NUCLEAR REGULATORY COMMISSION

Title: Advisory Committee on Reactor Safeguards
 (ACRS) Radiation Protection and Nuclear
 Materials Subcommittee

Date: June 23, 2015

So today we're here to show you the first seven chapters of the SER that we're preparing. We'd like to share with you our conclusions and receive feedback from you on how we've done so far.

Airways

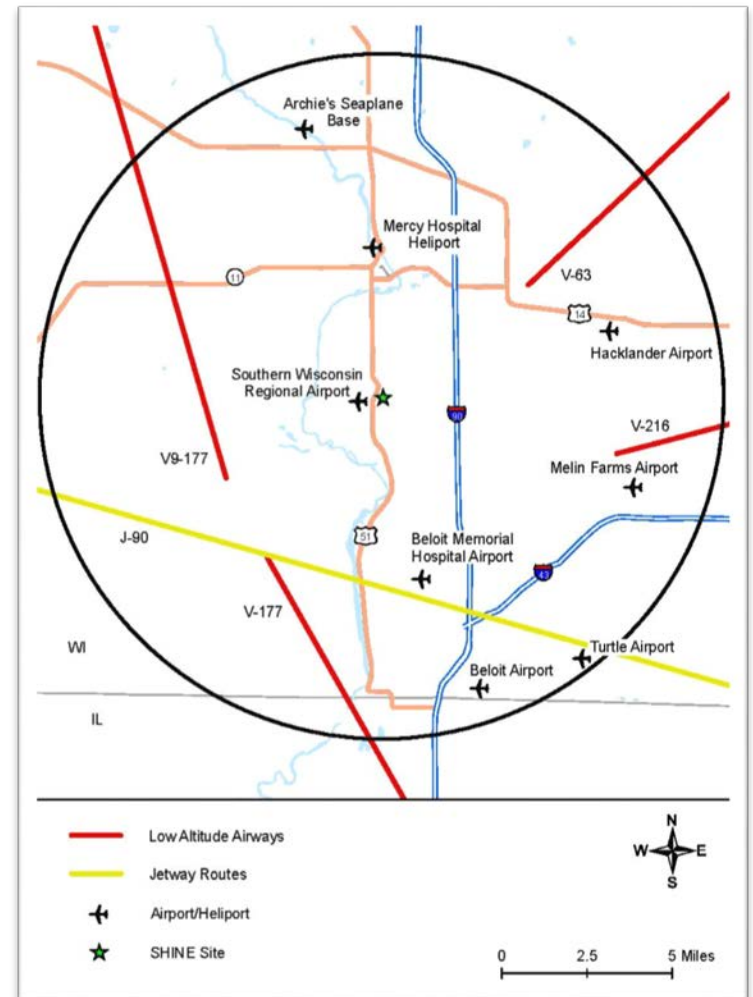
MEMBER STETKAR: And I've done a bunch of aircraft crash analyses. So, why doesn't this diagram that you have show all of the airways? And why does it show V-216 in a different location from

MEMBER STETKAR: We'll talk about methods later. This is a factual depiction as if these are the only airways and these are their locations, and this is not correct. Thank you.

I believe that's true; is that correct? I'm trying to read my notes and talk at the same time. My point is that the center lines of all of those airways, the center lines are about six miles roughly from the center point of the safety-related buildings. So, it's not clear to me how you can screen out any of them.

MR. HENNESSY: Yeah. I don't know when they did this analysis if it was different. So, we can't answer that. This is, you know, what we have, but -- and there are other VFR routes as well. The

FIGURE 7. Inverse Multiplication for 9 1/2 Inch Diameter Water Reflected Cylinder of High-Enriched Uranyl Nitrate

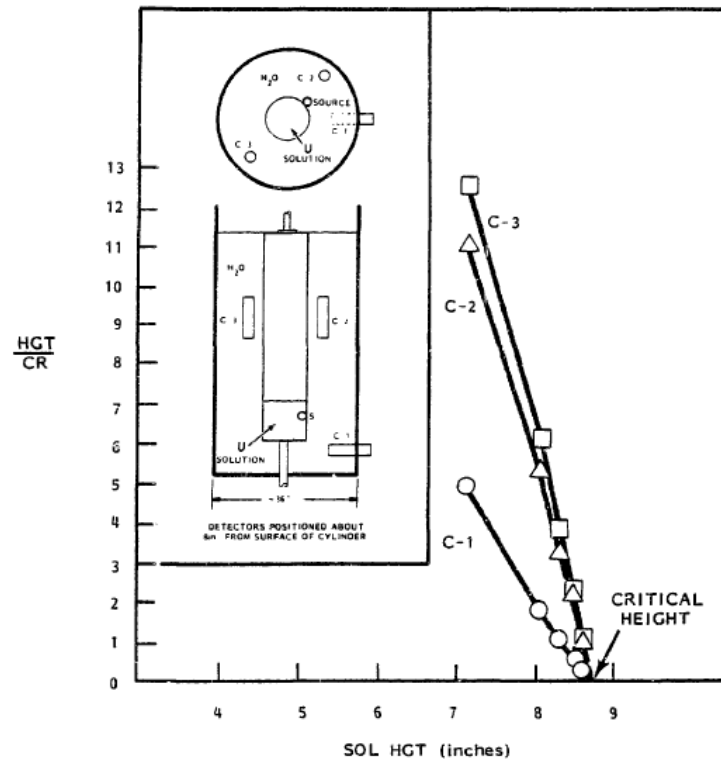
- In RAI 7a2.3-1, the staff requested additional information regarding the uncertainties, including a quantitative estimate of the expected overall uncertainty in their subcritical reactivity values during startup.
- In response, SHINE stated it plans to use a volume margin to critical approach, citing an example of overall uncertainty of 30 percent.
- The staff finds this response acceptable for a preliminary design.
